DSS433 DOCUMENT PROFILE SITE SURVEY AND SITE SELECTION FOR NUCLEAR INSTALLATIONS

Comments on IAEA Document Preparation Profile “Site Survey and Site Selection for Nuclear Installations” (DPP DS433)

Document Preparation Profile for Draft Safety Guide „Site Survey and Site Selection for Nuclear Installations“ (DS433)

Source: Figure 4-1: RD-346 Site Evaluation For New Nuclear Power Plants, November 2008, Canadian Nuclear Safety Commission.

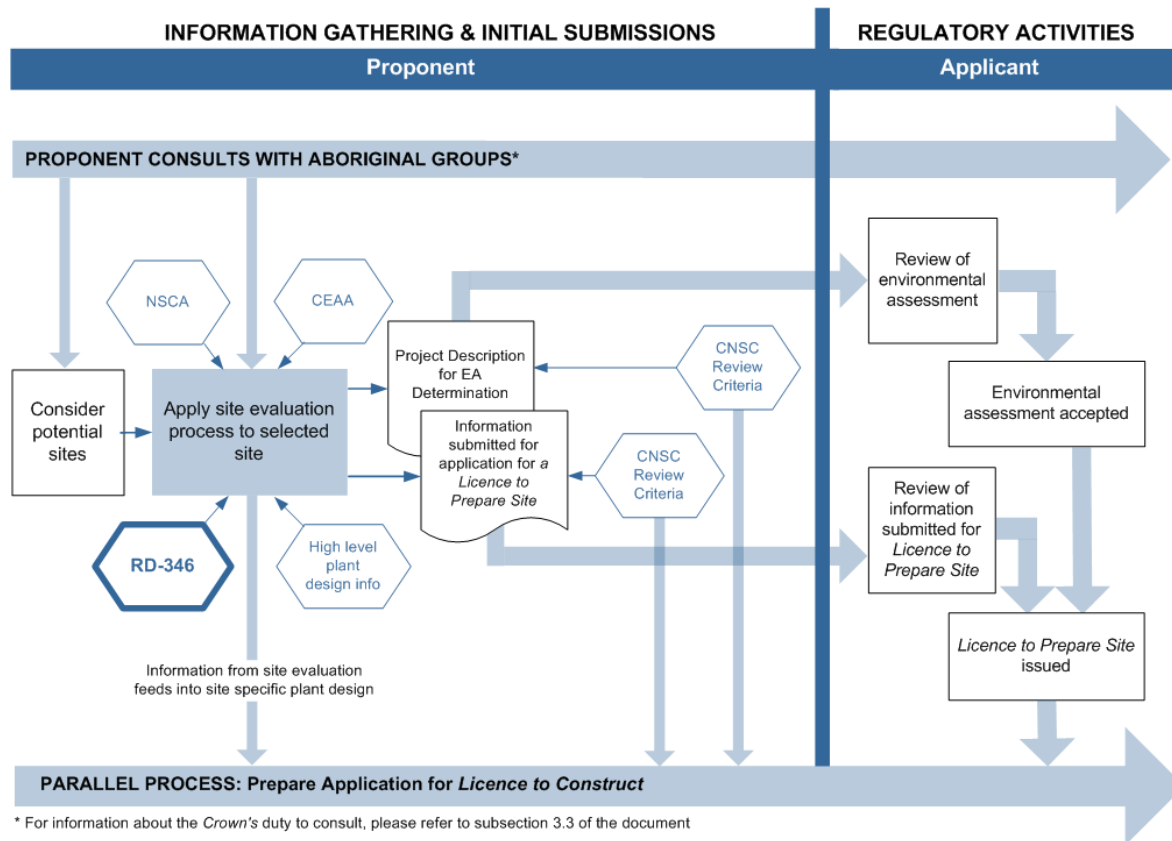
Comment No.	Para/Line No.	Proposed new text	Reason	Accepted	Accepted, but modified as follows	Rejected	Reason for modification/rejection
1	All	Consider that document may not be necessary. NS-R-3 can simply be applied at a higher level to determine candidate sites.	Canada modeled RD-346 “Site Evaluation for New Nuclear Power Plants” after NS-R-3, however early site surveys in Canada are unregulated. Any site can be chosen by a proponent (government or private), but the onus is on the applicant for the site preparation licence to build a “siting case” sufficient to defend the choice of site using RD-346 and an Environmental Assessment Process. (see page 4 of this form for a diagram) Generally, a proponent would use RD-346 (equivalent to NS-R-3) information at a higher level to establish a list of candidate sites, then select a site based on internal business needs before performing full site evaluation in more depth.			X	Countries newly embarking on a nuclear power program have expressed urgent need for a more detailed guidance than NS-R-3.

Additional information for Comment #1
